## ADDENDUM # 2

Project: **NEWBERRY MUSEUM** with bids previously due not later than 3:00 PM, January 25, 2018 but as of this addendum with a **revised bid date of January 30, 3:00 PM.**

Date of this addendum: **January 18, 2018**

**DRAWING TITLE**  
Bulletin Drawing  
**BDA002**

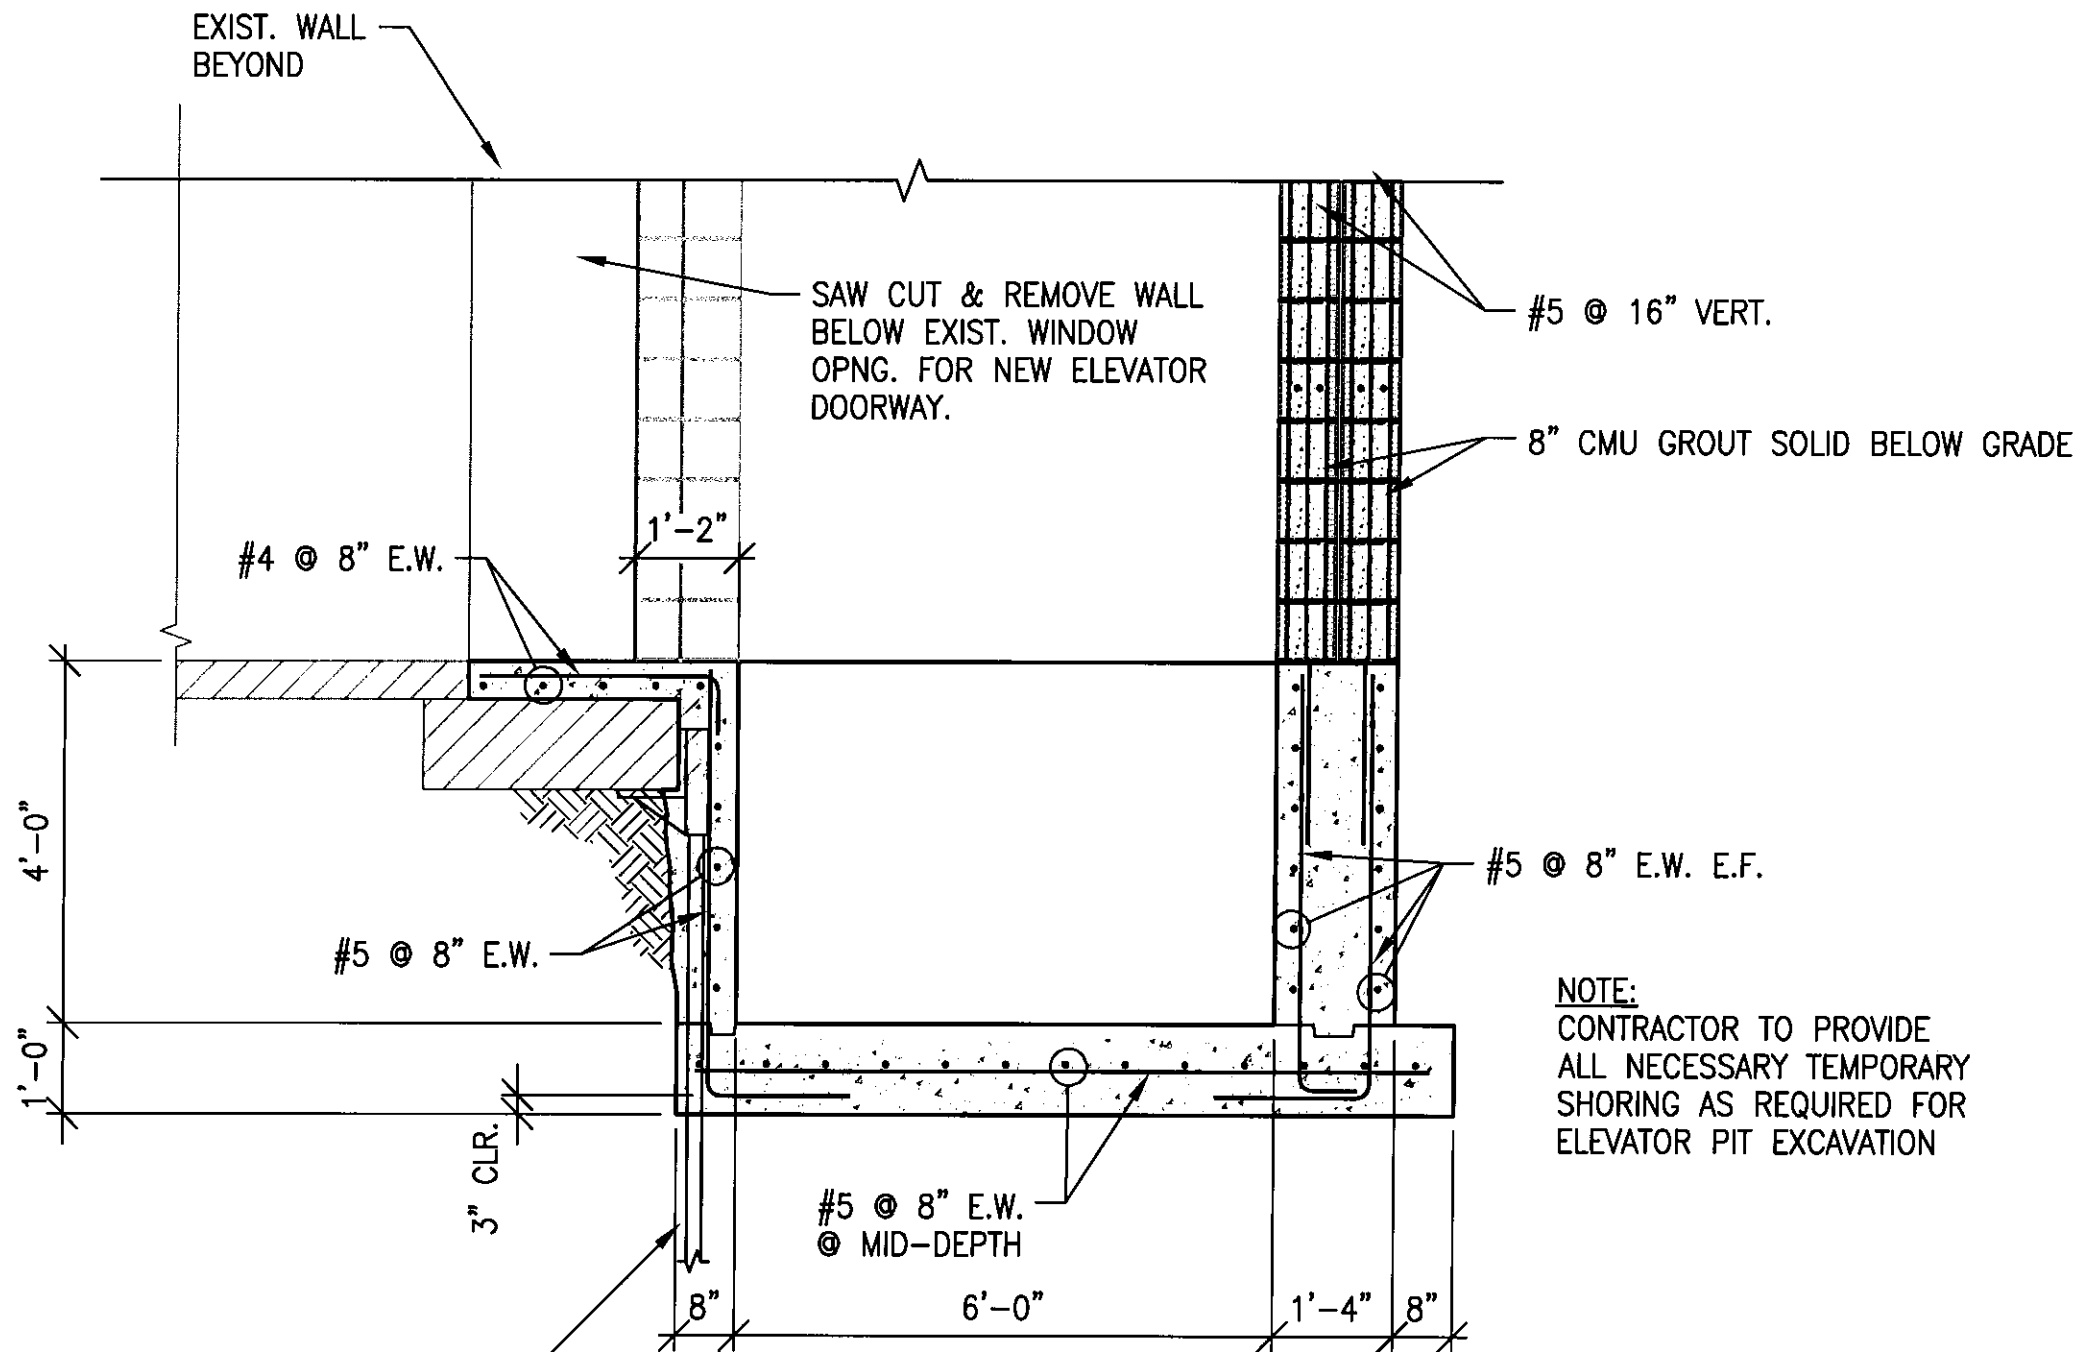
- a. **Addndm2.Exh W.BDA001.pdf** and **Addndm2.Exh X.BDA002.pdf** showing exterior precast steps and stucco-covered CMU retaining walls.
4. Supplement Structural drawing S4.1 with helical reinforcing piers for the existing foundation near elevator:
  - a. **Addndm2.Exh Y.BDS001.pdf** showing helical piers in section.
  - b. **Addndm2.Exh Z.BDS002.pdf** containing notes about the helical piers.
5. Electrical sheet E1.1: The four (4) Type Z4 light fixtures and circuiting originally designated as Add Alternate #4 shall be revised to include a note about the lights as follows: **"TO BE INCLUDED AS PART OF BASE BID."** This revision will eliminate Add Alternate #4.
